**BROOKFIELD STREETScape PHASE II  
STATE PROJECT NO. 0018-0136  
FAP NO. 0202(015)  
TOWN OF BROOKFIELD**

**MAY 2, 2019**

**ADDENDUM NO. 2**

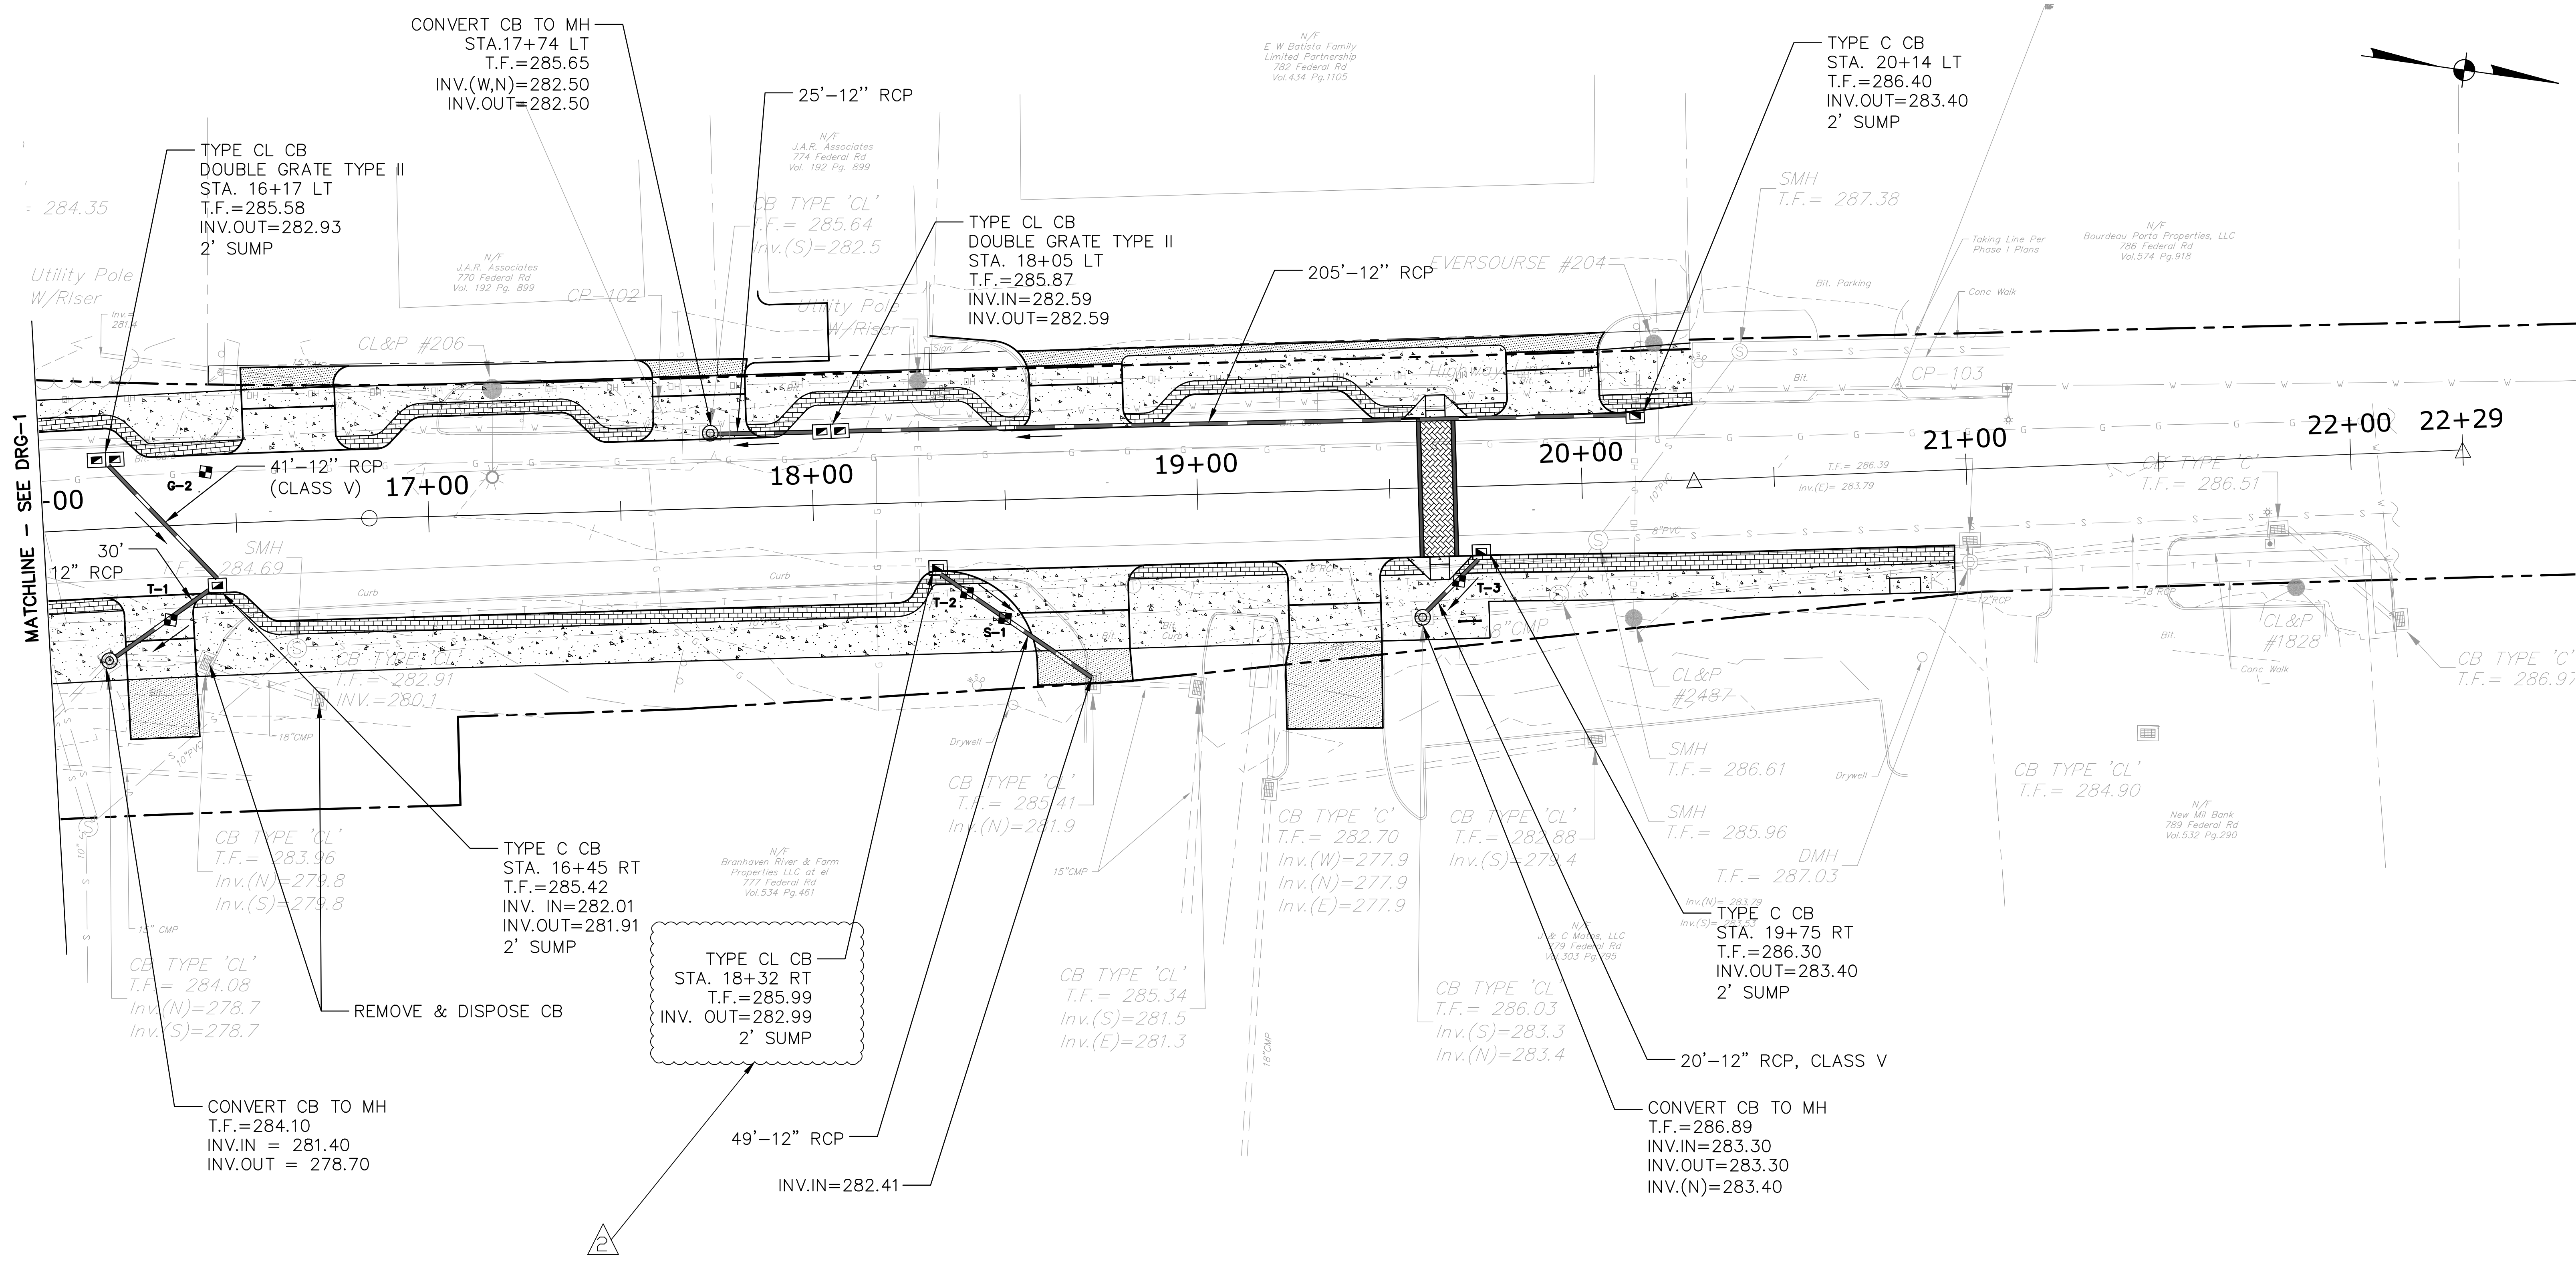
*Reason: Item numbers have been revised to reflect the use of all-inclusive drainage items. One Type "C" CB was changed to Type "C-L" CB to facilitate easier installation at a driveway. Monolithic Concrete Curb and Sidewalk was omitted and is hereby added to the contract.*

DESIGNED:	YL	TITLE:	PROFILE PLAN						
DRAFTED:	MK	SHEET NUMBER:	PRO-2.A2						
CHECKED:	RG								
APPROVED:									
SCALE:	AS NOTED								
PROJECT NO.:	2017-0605								
DATE:	10/30/2018								
FILE:	HW_MST_2017_0605_PRO								
<table border="1"> <thead> <tr> <th>NO.</th> <th>DATE</th> <th>DESCRIPTION</th> </tr> </thead> <tbody> <tr> <td>1</td> <td>05/01/19</td> <td>CATCH BASIN TYPE REVISED</td> </tr> </tbody> </table>				NO.	DATE	DESCRIPTION	1	05/01/19	CATCH BASIN TYPE REVISED
NO.	DATE	DESCRIPTION							
1	05/01/19	CATCH BASIN TYPE REVISED

DESIGNED:	YL	TITLE:	CROSS SECTION
DRAFTED:	PT	SHEET NUMBER:	XSC-5.A2
CHECKED:	RG	PROJECT NO.:	2017-0605
APPROVED:		DATE:	04/18/2019
SCALE:	1" = 5'	FILE:	HWL_MST_2017_0605_CS_FD
NO. DATE	DESCRIPTION		
05/01/19	CROSS SECTIONS REVISED TO REFLECT BRICK PAVER WIDTH		
	REVISIONS

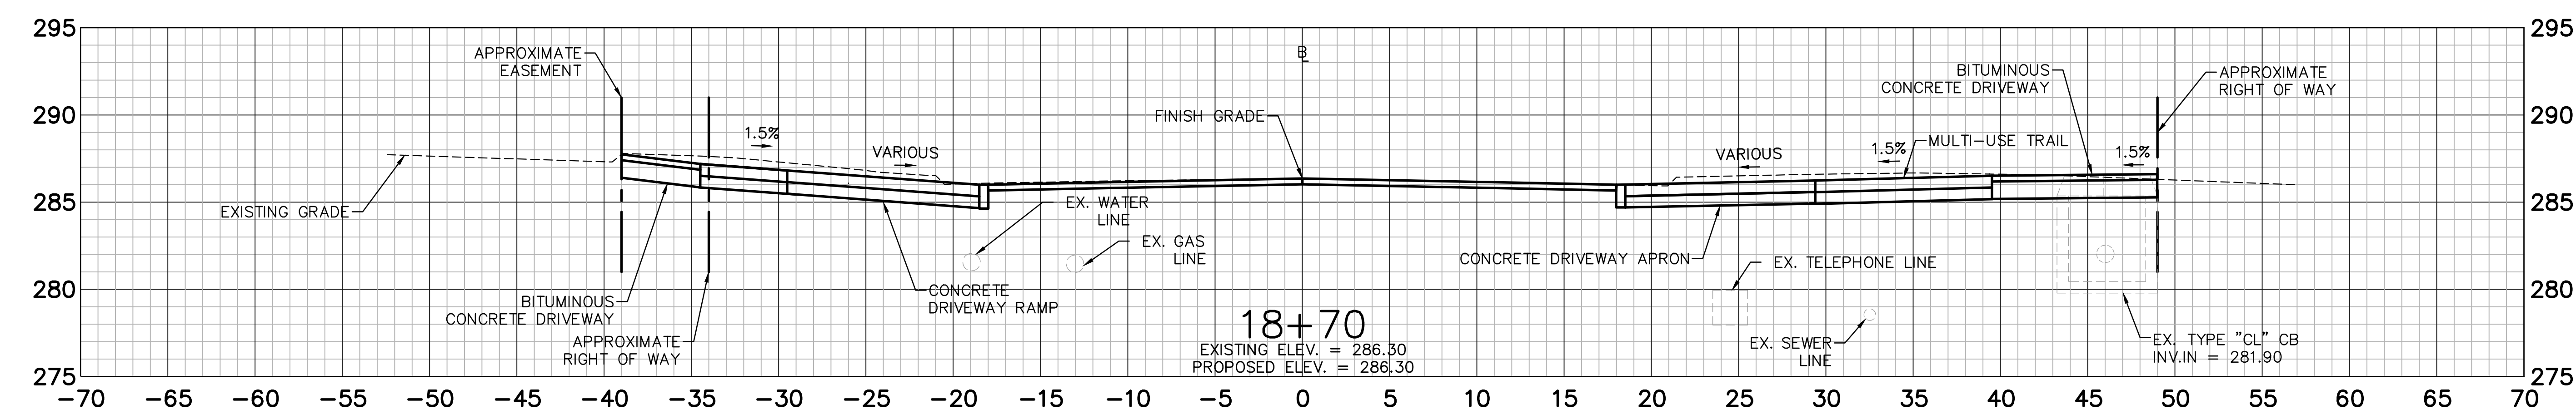
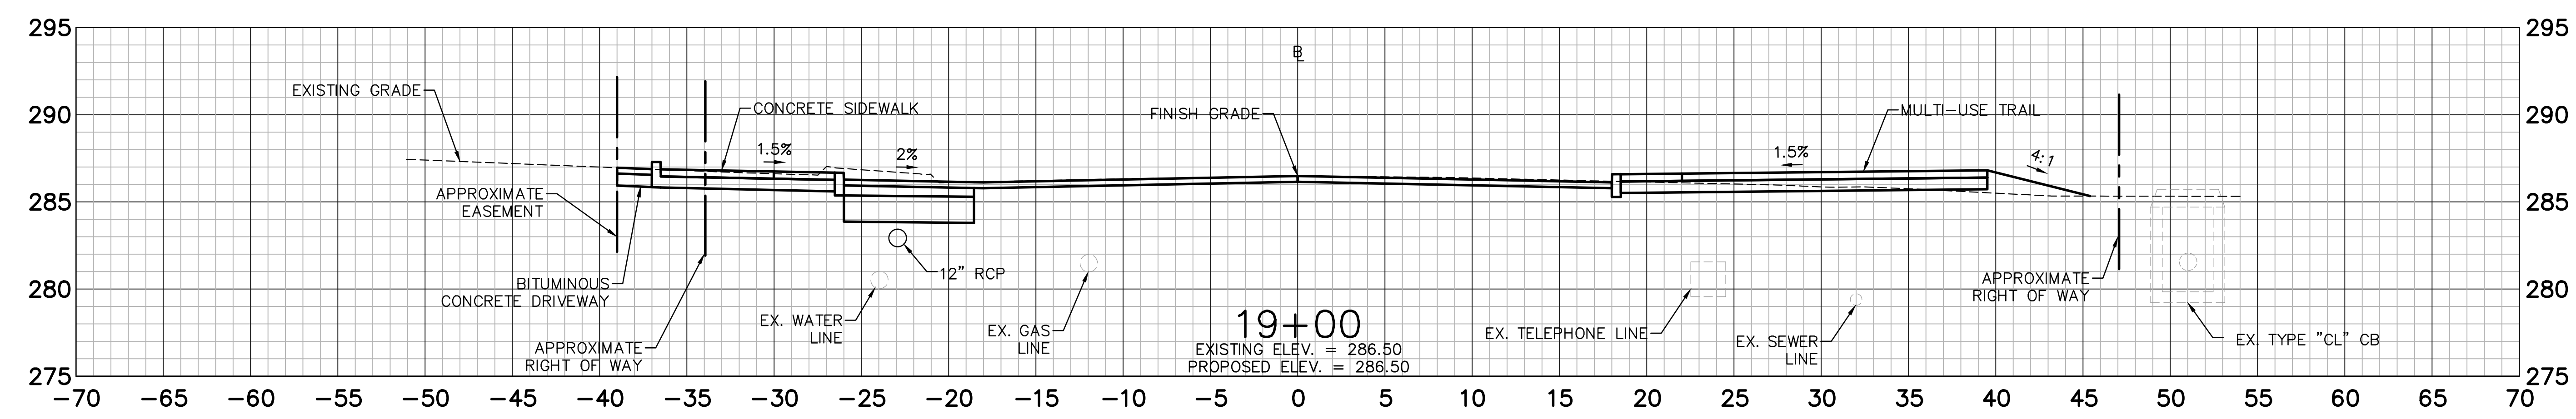
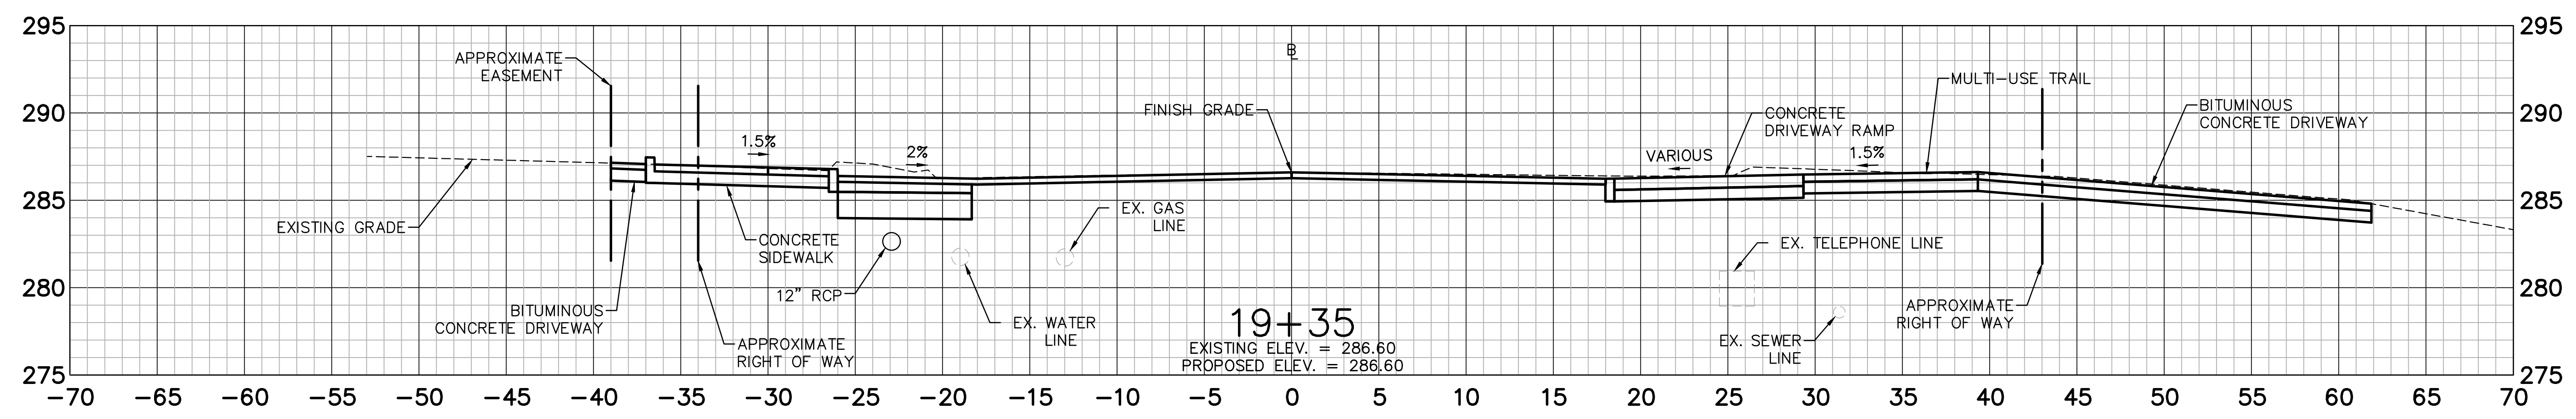
<b>SHEET NO.</b>	<b>SUMMARY OF REVISIONS</b>
<b>TITLE SHEET</b>	<b>General Note Revised</b>
<b>DE-1. A2</b>	<b>Item No. and Quantity Revised</b>
<b>TYP-1. A2</b>	<b>Driveway Slope Revised</b>
<b>TYP-2. A2</b>	<b>Driveway Slope and Legend Revised</b>
<b>MDS-1. A2</b>	<b>Miscellaneous Detail Callout Revised</b>
<b>MDS-2. A2</b>	<b>Miscellaneous Detail Revised</b>
<b>MDS-3. A2</b>	<b>Miscellaneous Detail Added and Revised</b>
<b>HWY-2. A2</b>	<b>Notes, Dimensions and Slope Limit Revised</b>
<b>PRO-2. A2</b>	<b>Catch Basin Type Revised</b>
<b>DRG-2. A2</b>	<b>Catch Basin Type Revised</b>
<b>XSC-1. A2</b>	<b>Brick Paver Width and slope limit Revised</b>
<b>XSC-2. A2</b>	<b>Brick Paver Width and slope limit Revised</b>
<b>XSC-3. A2</b>	<b>Brick Paver Width and slope limit Revised</b>
<b>XSC-4. A2</b>	<b>Brick Paver Width and slope limit Revised</b>
<b>XSC-5. A2</b>	<b>Brick Paver Width and slope limit Revised</b>

TITLE: <b>CROSS SECTION</b>
SHEET NUMBER: <b>XSC-6.A2</b>

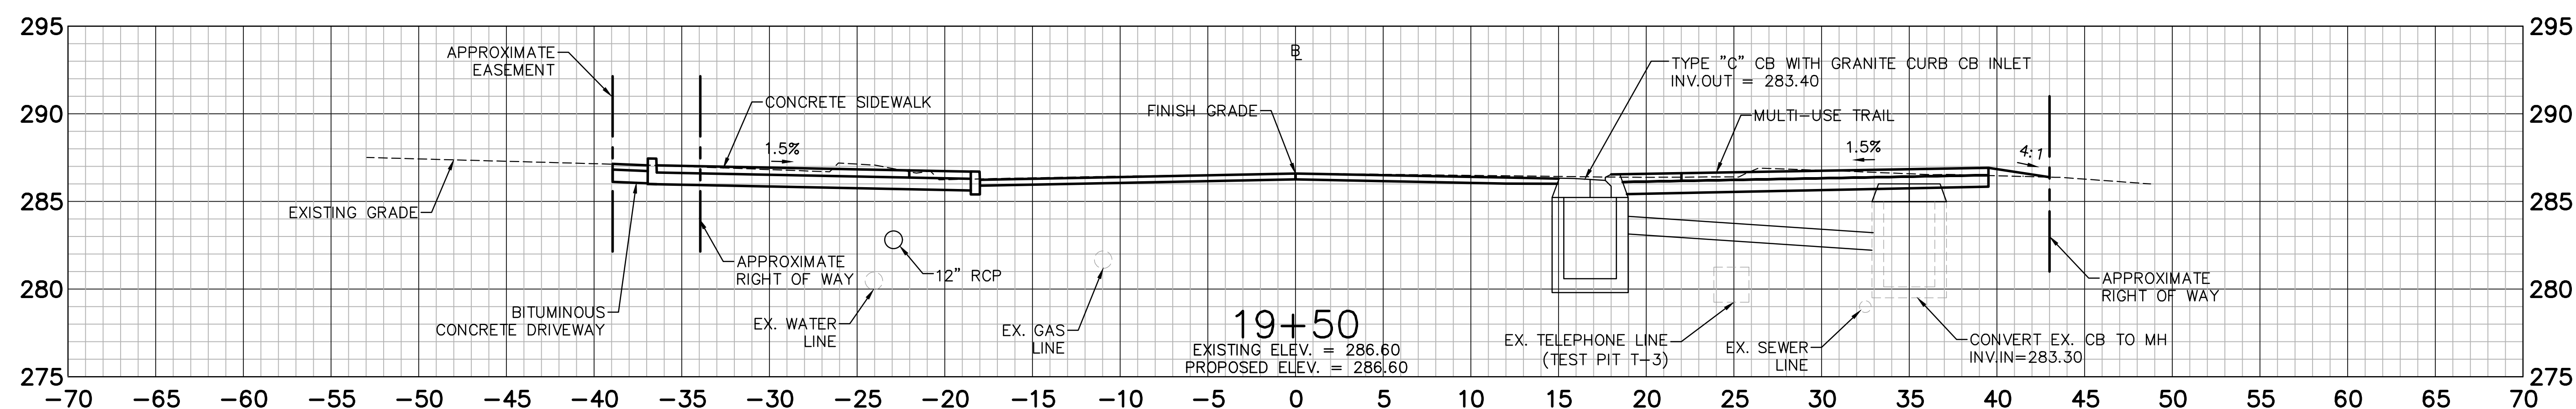
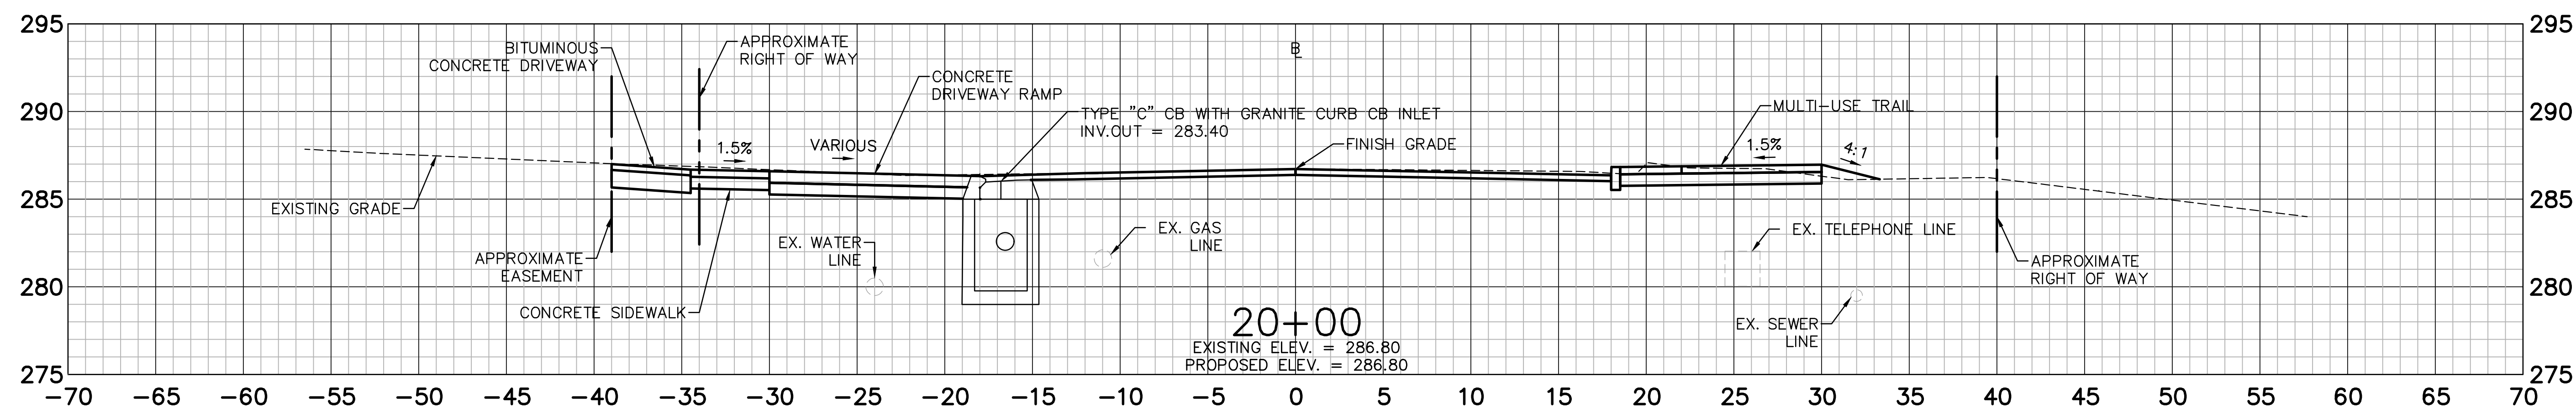
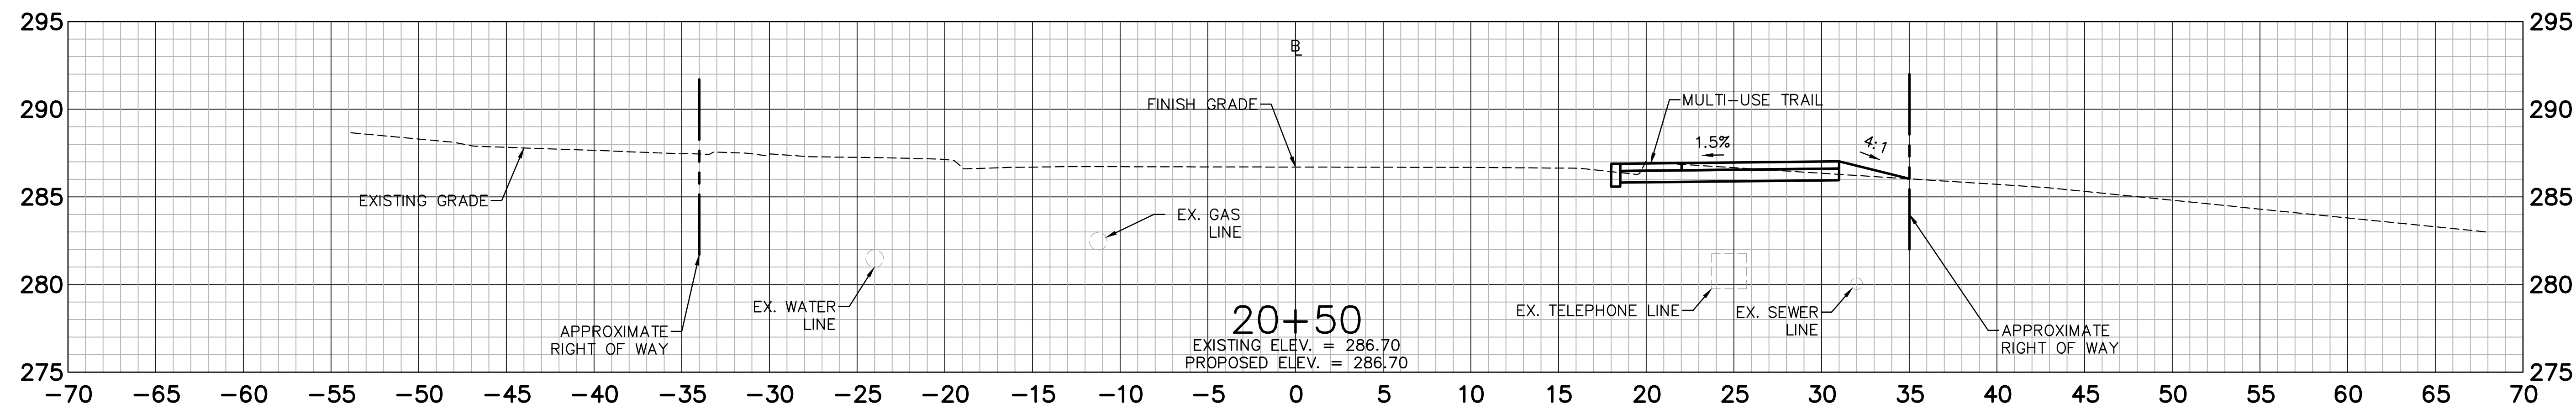
<b>XSC-6. A2</b>	<b>Brick Paver Width and slope limit Revised</b>
<b>XSC-7. A2</b>	<b>Brick Paver Width and slope limit Revised</b>

NO.	DATE	DESCRIPTION
1	05/01/19	CROSS SECTIONS REVISED TO REFLECT BRICK PAVER WIDTH
REVISIONS
